Block 2 Servicing Strategy for the Fruitland

- Winona Secondary Plan Lands

Appendix A

Sewer Design Tables and Figures

Natural Hazards and Environmental Constraints Assessment

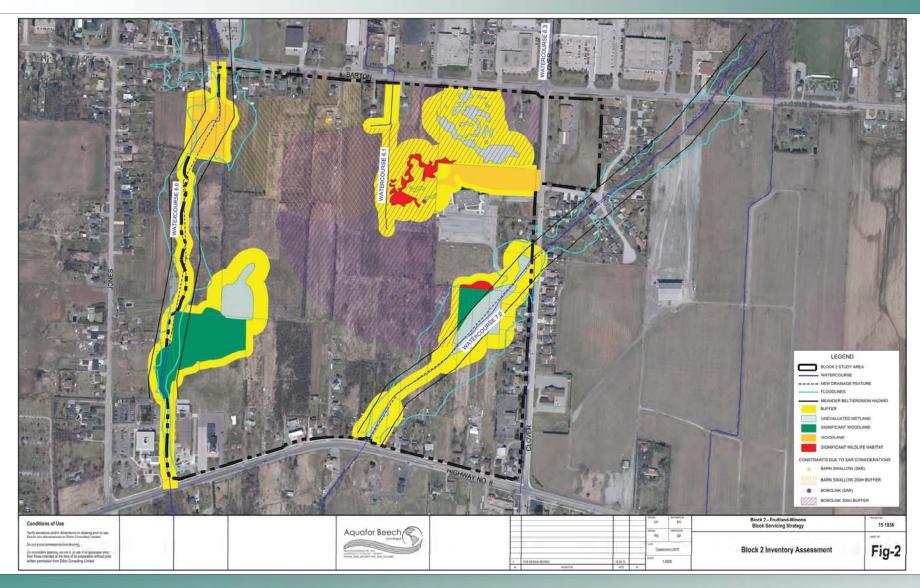
- 1) The aerial photograph used in the presentation material does not reflect the existing conditions of the lands.
- 2) The Natural Hazards and Environmental Constraints Assessment (Fig-2) identifies significant wildlife habitat, unevaluated wetland and an unidentified polygon. As acknowledged by City staff and the consultant, this information is not based on site specific fieldwork on the lands. In our opinion, this information should not be depicted as a constraint. Our client retained Mr. lan Barrett (Colville Consulting) to complete site assessment and field verify to determine if there were any natural features or habitat on the lands. A technical memo from Mr. Barrett is attached to this letter. Mr. Barrett concludes that the majority of the properties are currently being used for the cultivation of agricultural crops and no vegetation communities on the property are consistent with wetland; and, the property does not appear to meet any of the criteria to be

Stormwater Servicing (Existing VS Proposed Drainage)

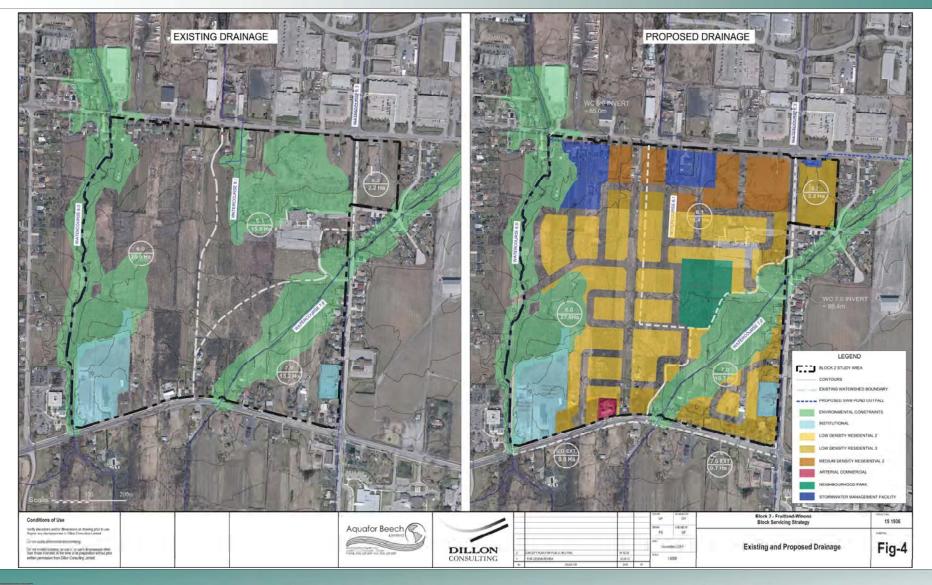
- 3) The Stormwater Servicing slide (Fig-4) identifies existing 'Environmental Constraints', however in the 'Proposed Drainage Plan' the lands are shown with a full development concept. Based on this mapping, it would appear the report is suggesting that all the lands are developable. We would agree that there are no constraints to development of the lands. We ask that the City confirm that the intent is that the lands are fully developable and that there is no further study required at this time or for a future application.

We are deeply concerned that the "Existing Drainage" (Fig-4) does not accurately map the actual historical path of stormwater. Significant amounts of water run north at the main entrance of the stormwater, (but not south of the entrance?), then around the corner west along Barton to Culvert 6.1. We do not understand why the existing Stormwater Management systems are not indicated on the "Existing Drainage" map, nor the Storm Sewer Plans, Minor (Fig-6) or Major (Fig-7).
